# **SUGAVE AND SIX VILLAGES WATER SUPPLY SCHEME**

**Mridul Joshi**

**Nikhil Kumar**

**Prof M. Sohoni**

Figure 8.1 : Plot of head (in m) at Naldhe ESR as function of flow output (in lps) at Borwali ESR with current physical assets

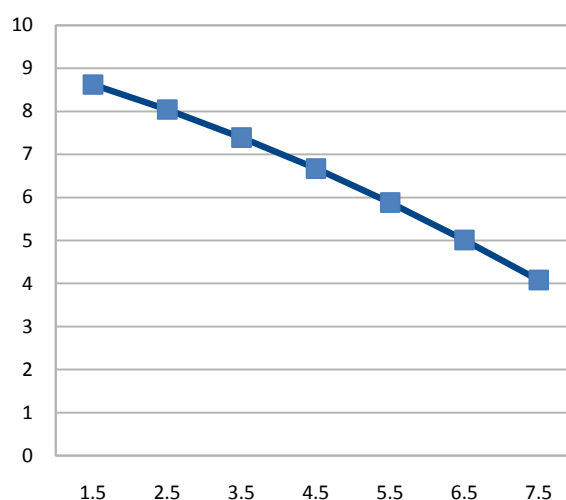
The above simulation shows if water outflow at Borwali ESR crosses 6.5 lps then the head at Naldhe will drop less than 5 meters. Though system is designed for outflow of 3.36 lps at Borwali ESR, it may go much beyond it with wrongly configured pressure valve as the head is as high as 24 meters.
